# **Central Planning Authority**

**Minutes of a meeting of the Central Planning Authority held on February 03, 2021 at 10:00am, in Conference Room 1038, 1<sup>st</sup> Floor, Government Administration Building, Elgin Avenue.**

**CPA/03/21**

Figure 1: DOE's 2013 Habitat Map Extract showing application site outlined in blue

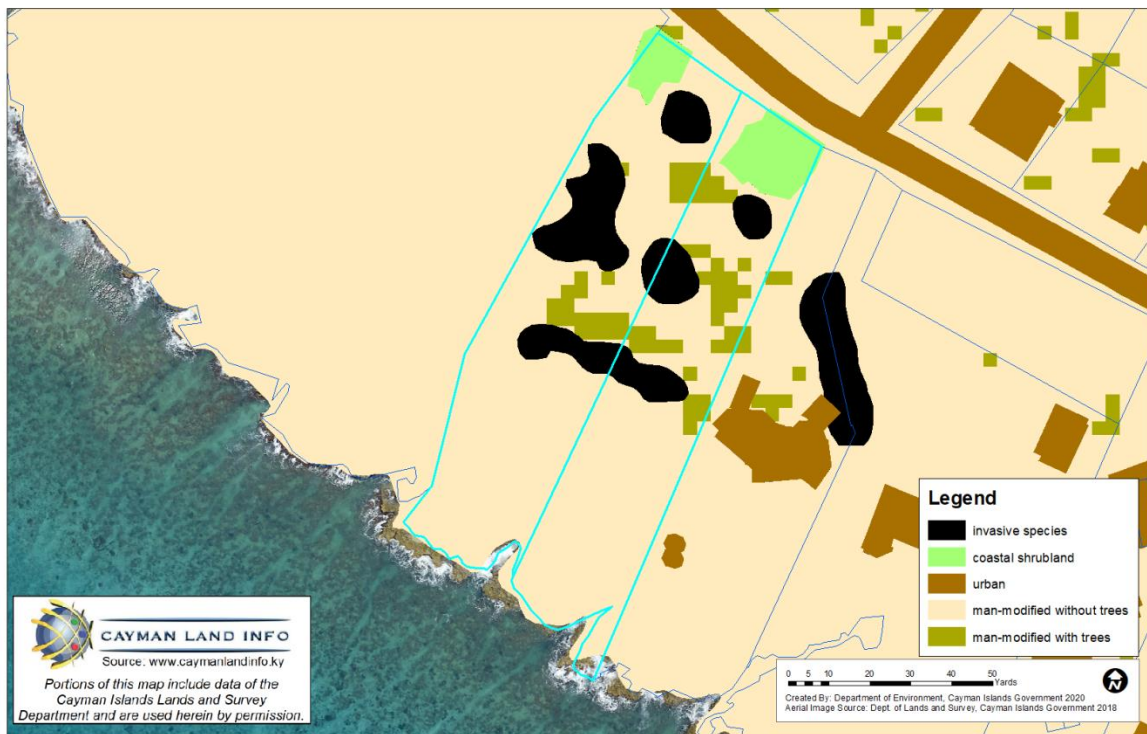
*The application site is man-modified with some primary coastal shrubland habitat in the northern section as shown in Figure 1. The site is also located adjacent to a marine protected area (a Marine Park) and is on a high wave energy coastline with deep water offshore. It is also noted that the site and the property immediately to the west have a unique geological feature in the form of a split/fissure in the ironshore, as shown in figure 2*

Figure 2: LIS 2018 Aerial Imagery showing geological feature (circled in red) and the application site (outlined in blue). Source: Cayman Land Info

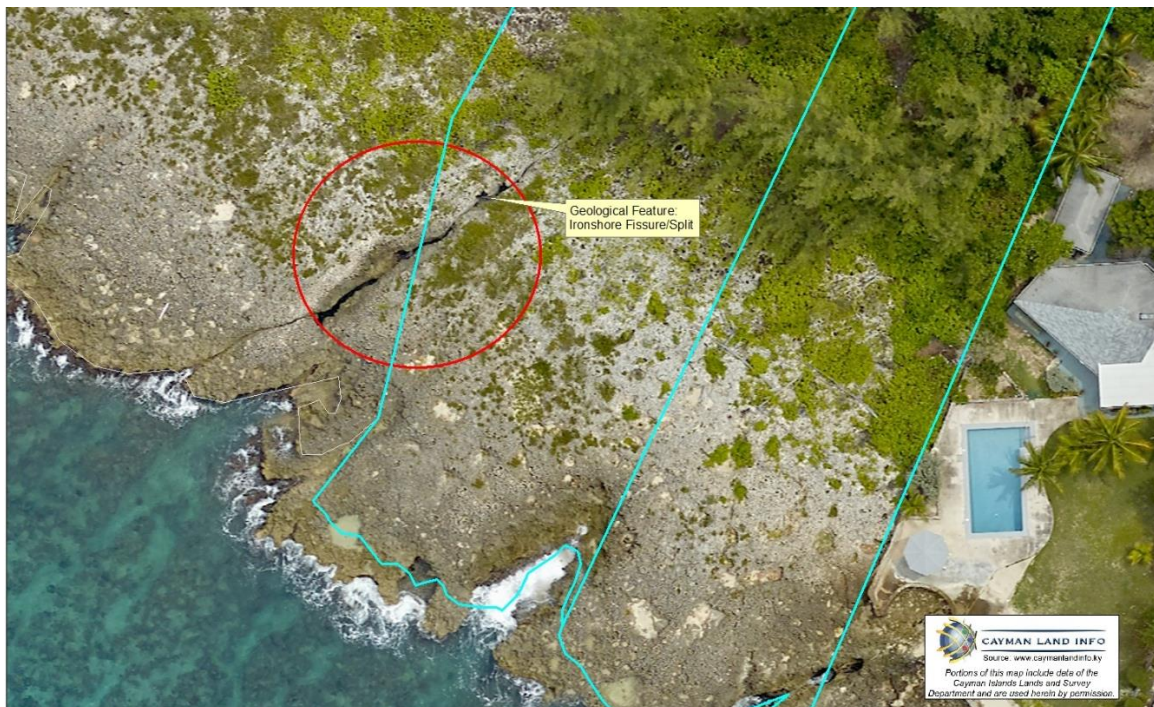
This stretch of coastline has a history of coastal property damage during storm wave action. Figure 3 shows the impact Hurricane Ivan had on the site and the position of the remaining vegetation in the 2005 image illustrates the extent of storm wave incursion. We

*therefore recommend that the setbacks are maximized to the greatest extent possible. We would also encourage the use of climate change resilient design features such as wash through ground floors. This would assist in reducing storm surge impacts.*

*Figure 4: Extract of submitted plans overlaid on LIS 2018 aerial imagery showing the proximity of the split/fissure to the western proposed dwelling (Source: Declan O'Brien Architectural Services & Cayman Land Info)*

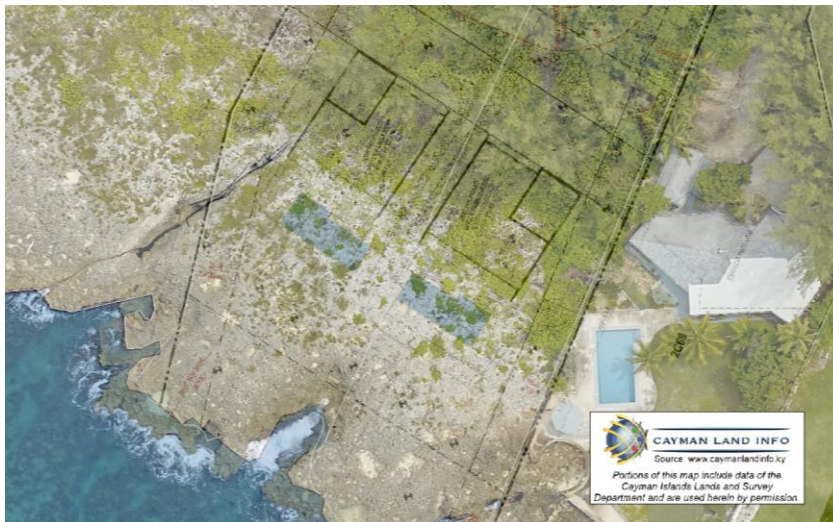
*The western single family home is extremely close to the ironshore split/fissure, and the DoE will not support any future filling of or works to the split as it is directly connected to the sea and Marine Park. The DoE would urge the applicant to seek advice from a structural engineer to ensure that the split/fissure does not cause a threat to the structural integrity of the property. The home could also be impacted as the split/fissure is directly connected the sea, and could potentially bring storm waves closer to the property during inclement weather.*

- DOE's figure 4 shows the proximity of the proposal to their house and pool and this will impact their use of the outside area which they use a lot
  - The proposal is out of keeping with the neighbourhood

**Figure 2: Elevation model showing the South Sound drainage basin (outlined in red) and the approximate location of the application site within the blue outline.**

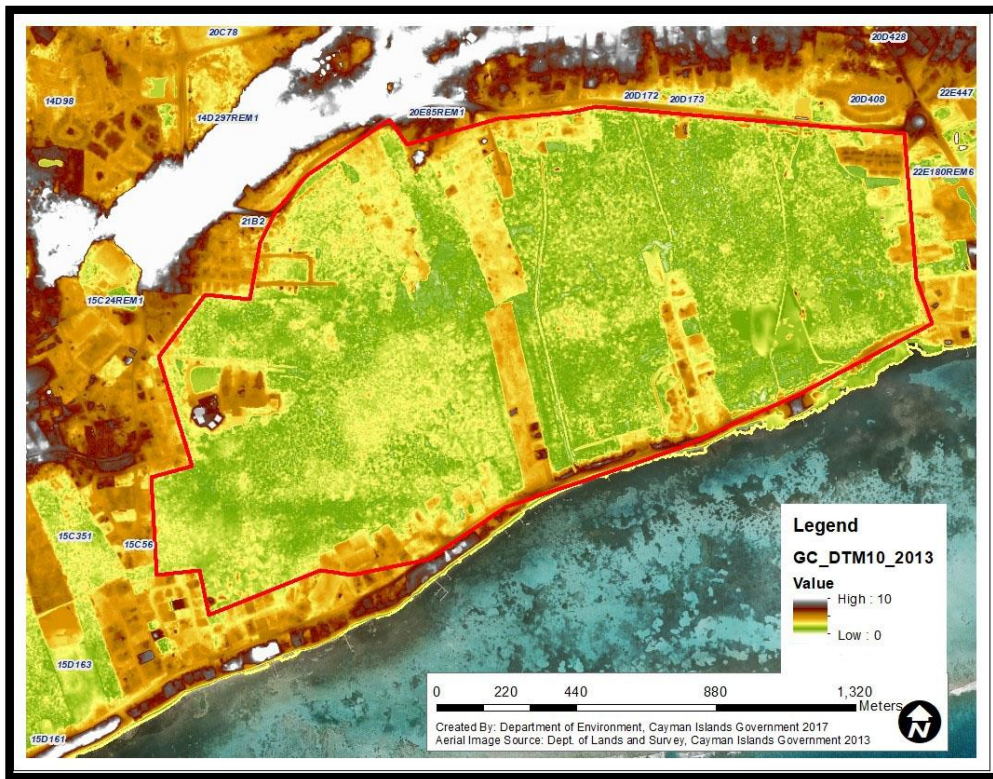
*The subject parcel of mangrove habitat is located within the South Sound drainage basin (see Figures 1 & 2). The South Sound basin functions as a water catchment and storage basin which provides flood controls and storm-water retention. Surface water is stored in the wetlands, which provides a natural mechanism for reducing flow velocity and flooding. This basin also contributes to the maintenance of water quality in the South Sound Lagoon. Unfortunately, the South Sound drainage basin has become severely fragmented by current and future developments impacting the overall capacity of the remaining wetland area to accommodate drainage for the whole basin.*

The DoE has consistently raised concerns about the lack of a comprehensive stormwater management strategy for the South Sound drainage basin over the years. As outlined in the attached Memo dated 30 January 2015 (5 years ago) from the DoE, Water Authority and National Roads Authority, to the Ministry of PLAHI, there are significant concerns regarding the development of this area without an adequate comprehensive stormwater management strategy. The specific recommendation of the Memo was **“to issue an RFP to select a suitably qualified consultant to undertake a hydrological assessment of the South Sound drainage basin and devise a regional stormwater management plan, which will include drainage engineering specifications for the proposed road and future development and Best Management Practices to minimise the impacts of stormwater flooding”**.
